**CLINCH RIVER
BREEDER REACTOR PROJECT**

**PRELIMINARY
SAFETY ANALYSIS
REPORT**

VOLUME 20

Figure 130.89-3. Liner Failure at (A) Corner Joint and (B) Intermediate Joint

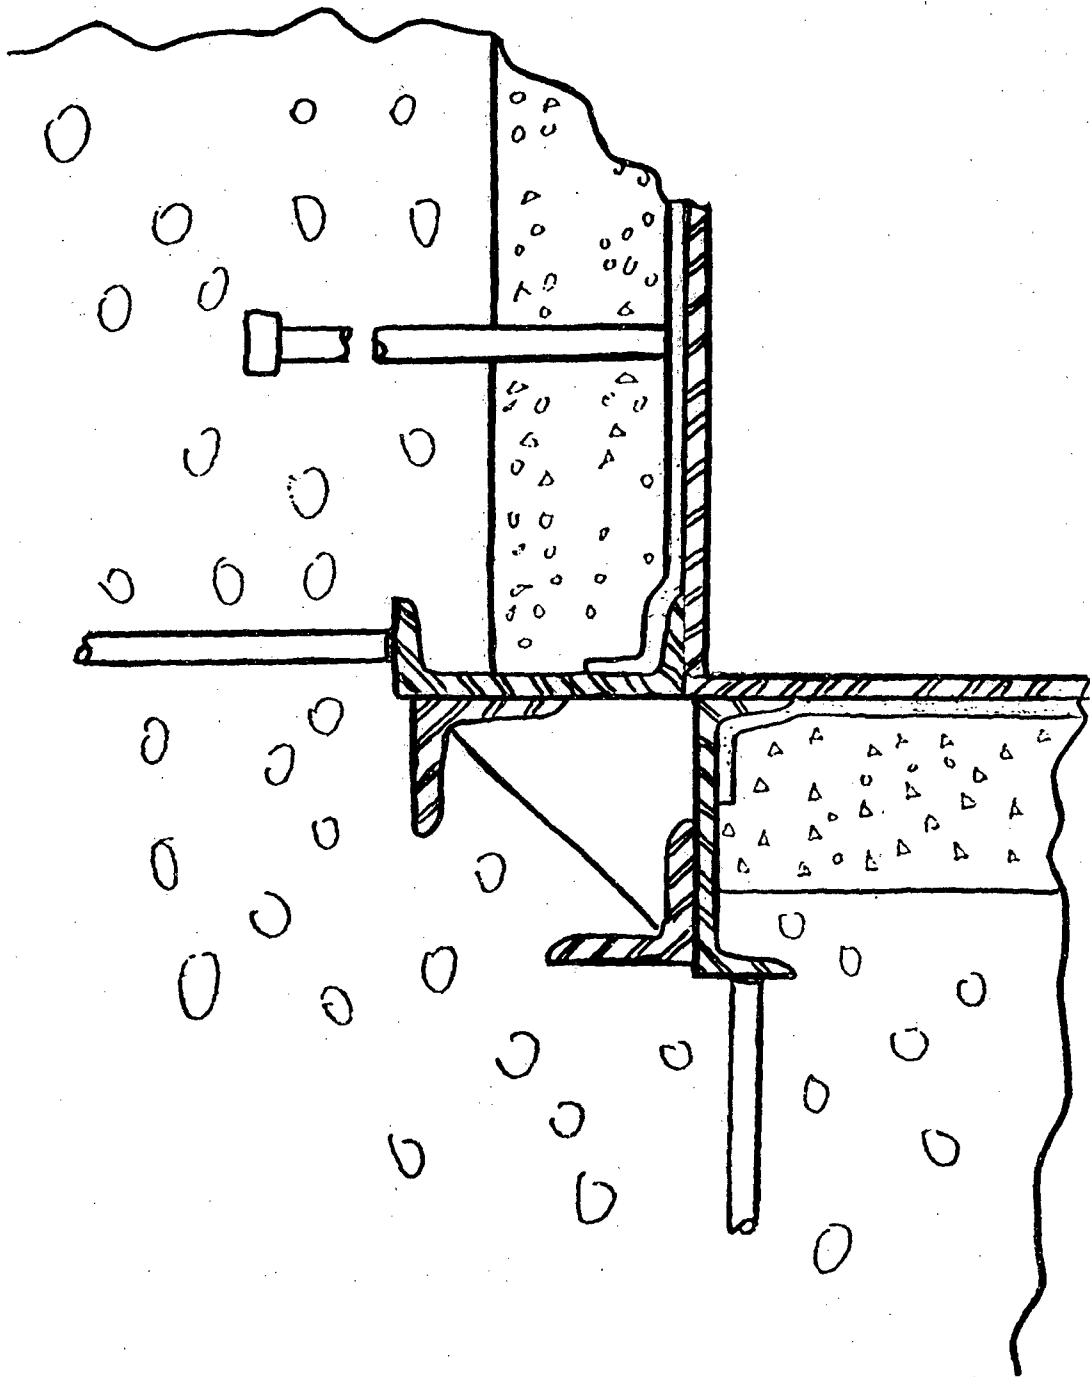
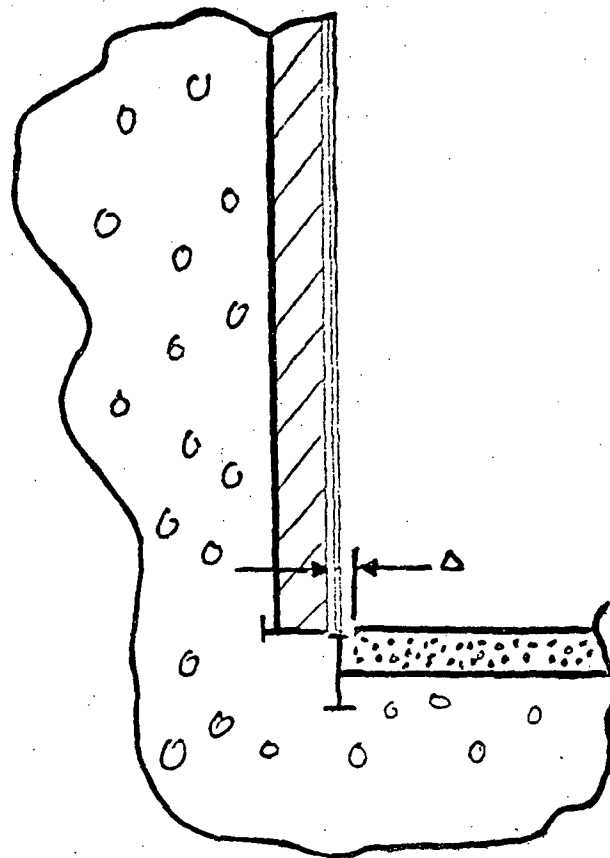
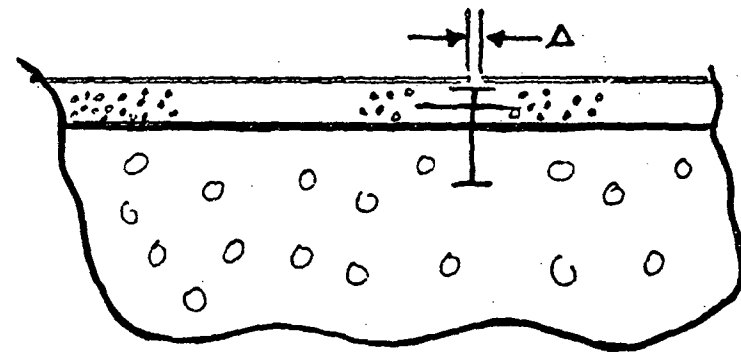
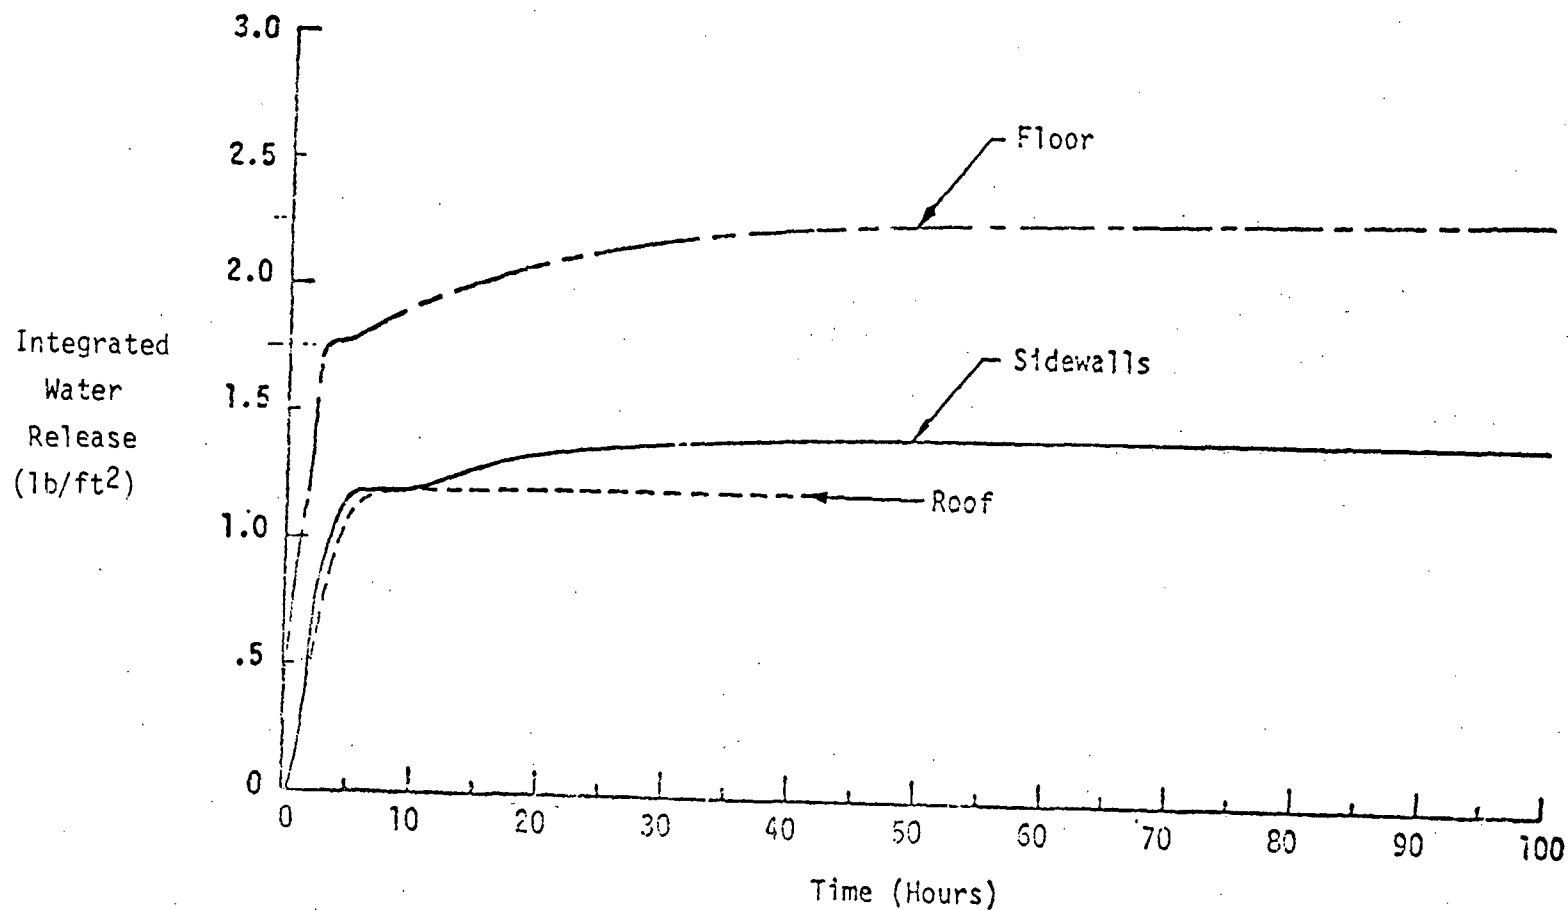
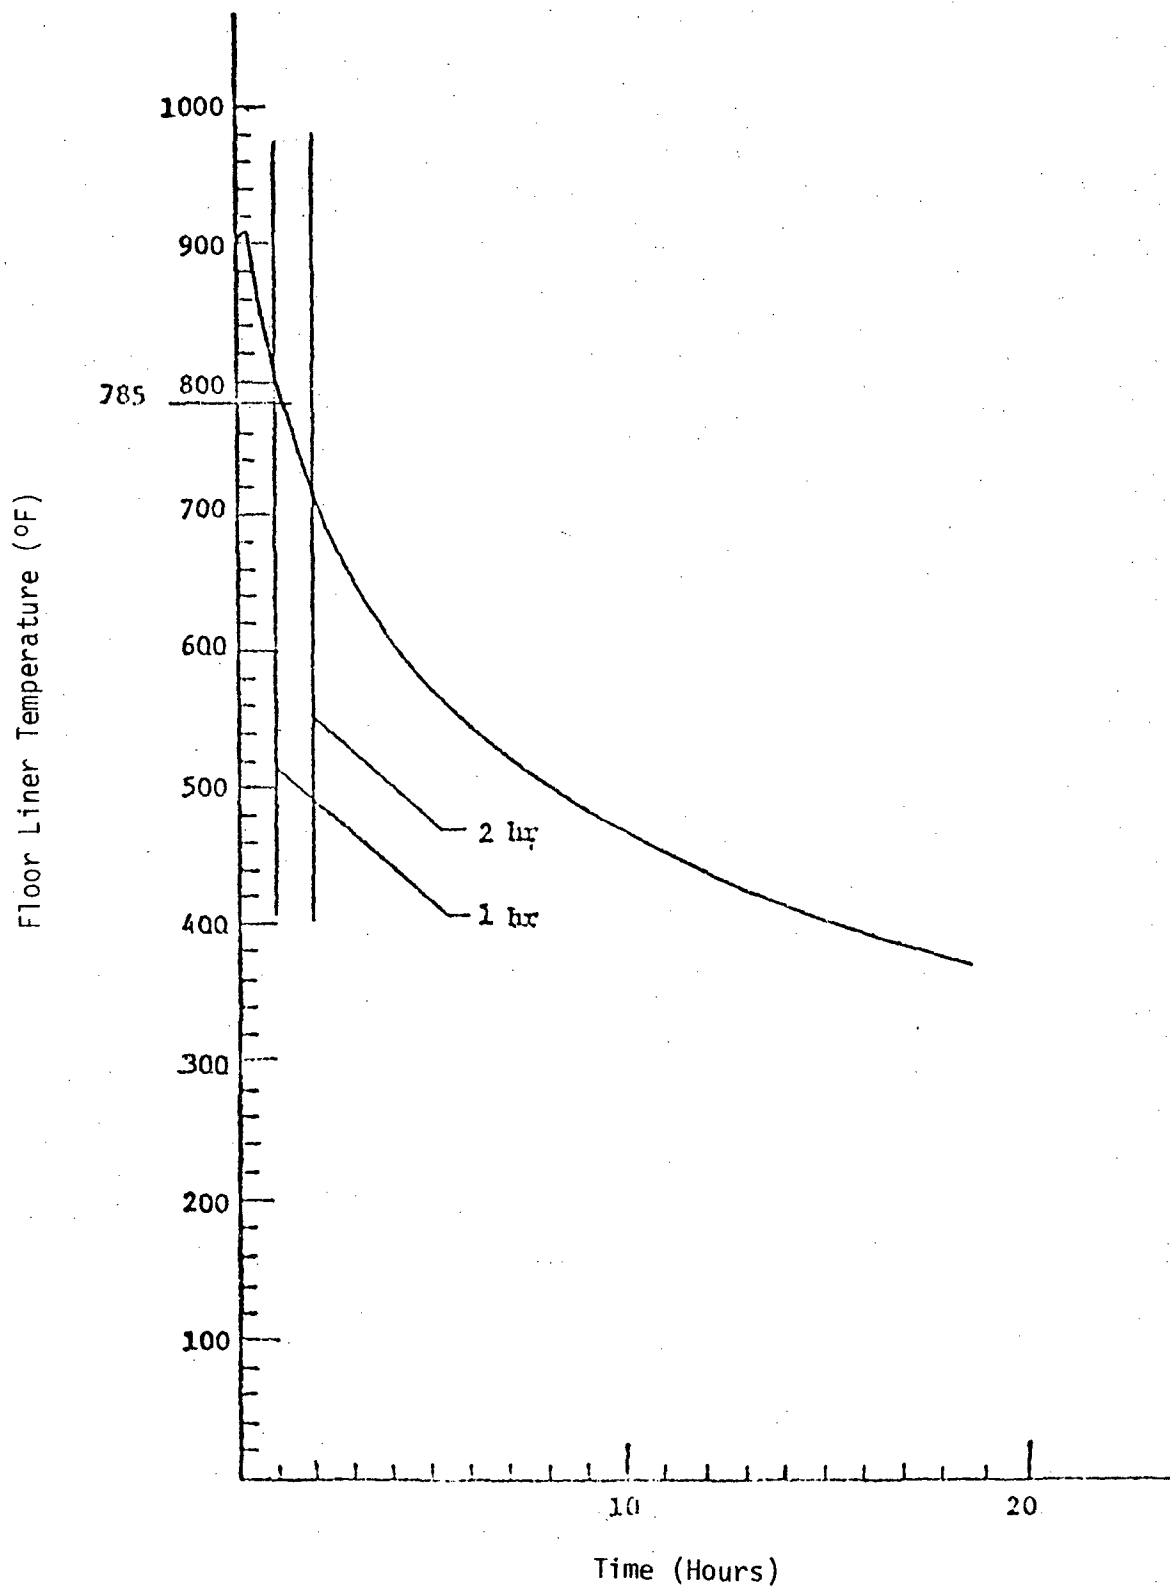
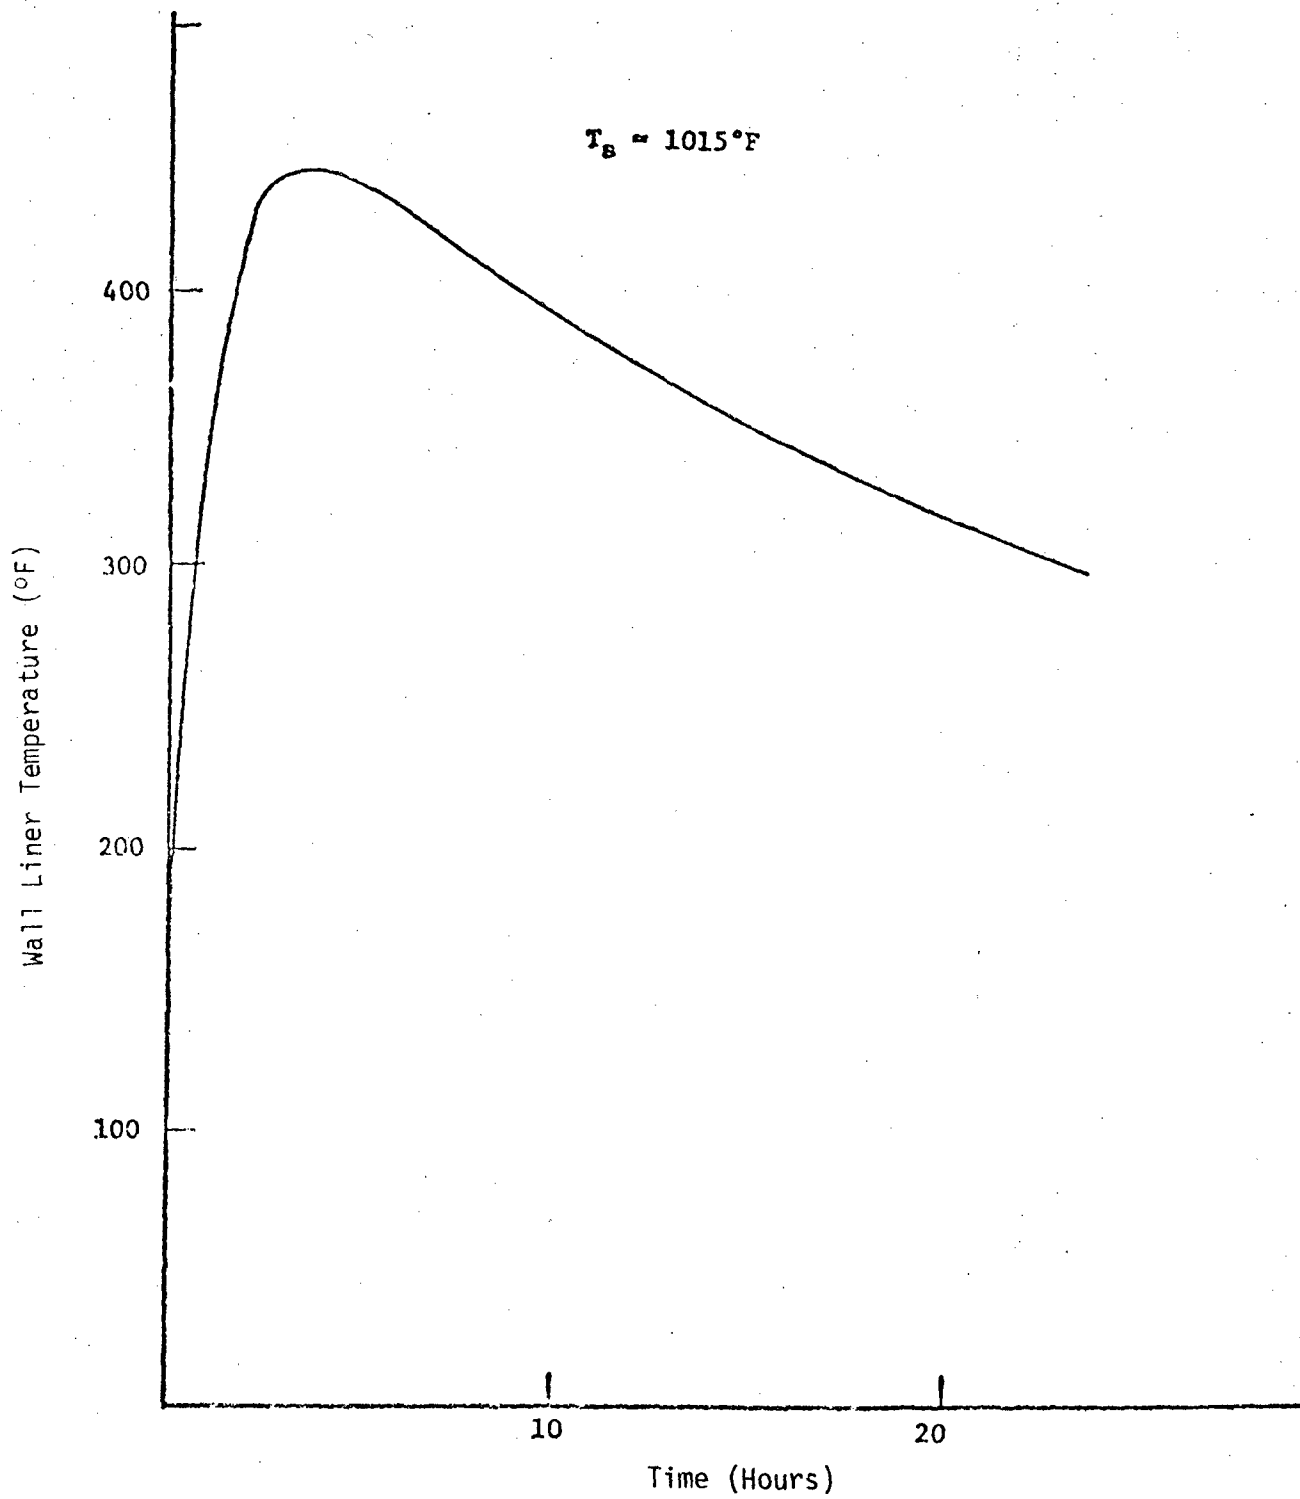
In Figure III-2, the space between the floor slab and the floor liner plate is filled with aggregate. If the floor liner plate is so designed that the gravel will support any load applied to the floor, indicate the method of construction used to assure an adequate support for the liner by gravel during construction and in service, and the criteria of acceptance for the layer of gravel. Also indicate how the floor liner plate is analyzed.

Figure 3 illustrates the location of the assumed crack at (A) the wall to floor junction and (B) an intermediate joint in the floor of the cell. In both cases, the sodium pool is assumed to be deep enough to cover the entire floor and stand a significant height up the wall. If the sodium pool were very shallow (i.e., a small volume spill compared to the cell floor area), the equilibrium temperature of the liner-sodium pool would be much less than the spill temperature. Thus it is assumed that a large sodium spill is of the most interest and the pool will completely cover the floor to a significant depth. This will result in complete immersion of the cracked portion of the liner in the sodium.

sodium spill in a PHTS cell from a spill of 21660 gallons of sodium. The spill temperature was assumed to be 1015°F. Figure 5 shows the thermal response of the floor liner and the structural concrete for this spill case. It is noted that the maximum temperature of the liner for this spill was calculated to be 910°F. The temperature drop necessary to cause a tear would be 125°F evaluated using minimum yield strength properties. From Figure 5, it can be determined that the liner temperature drops by this amount in approximately 1.3 hours. From the detailed data used to construct Figure 4, it was determined that 60% of the total water that would be released (if the liner did not fail) has already been vented from behind the liner. Also, the surface of the structural concrete will contain very little remaining free water. As can be seen from Figure 6, the wall liners cool down much slower than the floor liner and therefore remain in compression longer. This supports the assumption that the floor liner would be more likely to fail first.

TYPICAL CELL LINER ISOMETRIC
CORNER DETAIL (SK-5)

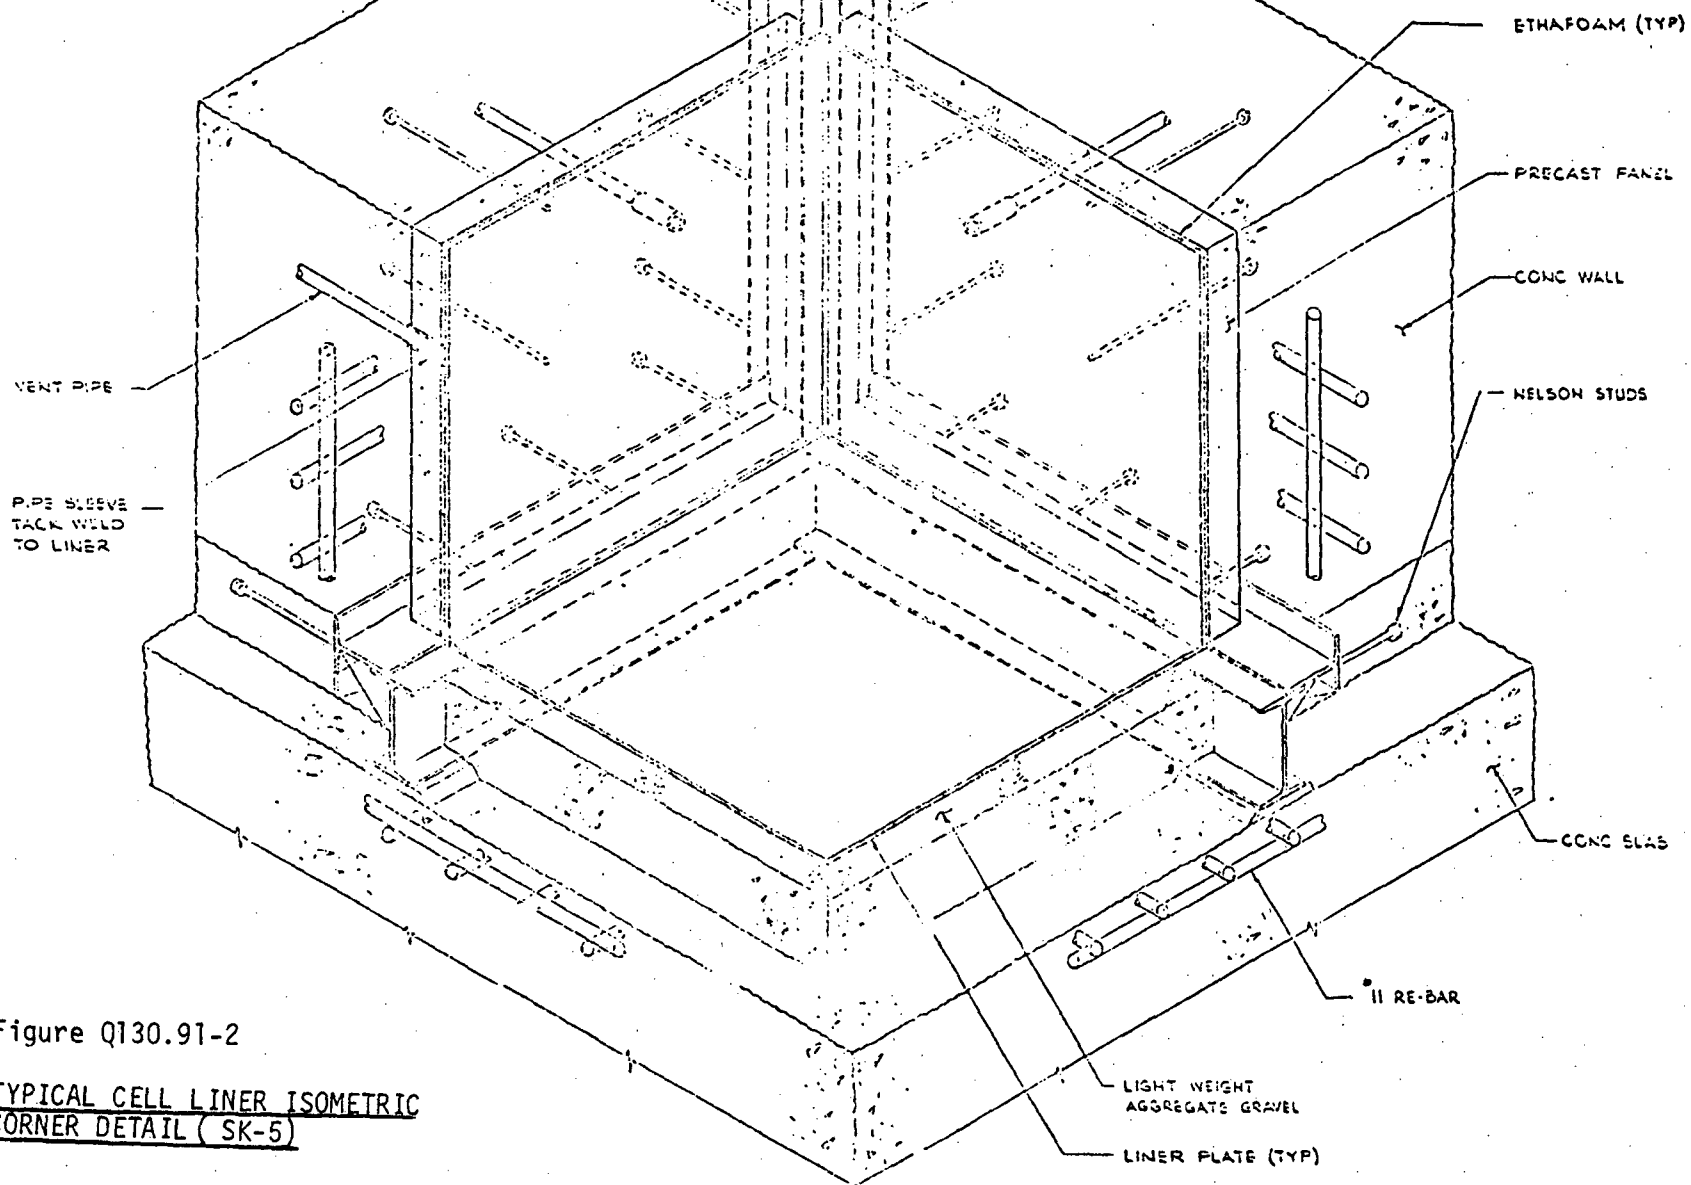
Indicate the criteria which were used in adopting the corner detail design as shown in Figure 3. If the design has been changed describe the new one and state the rationale for the change.

The corner detail of Figures 1 and 3 of the June, 1976 Report has been changed to a straight corner detail as a result of stress analyses performed. The original curved corner detail resulted in excessive shear strains in the wall panel stud anchors. By using the detail shown in PSAR Figure 3A.8-4, the thermal expansion of the plate at the corner has been limited which results in smaller displacements and lower strains and stresses at the anchors. PSAR Figure 3A.8-6 shows a typical cell liner isometric-corner detail.
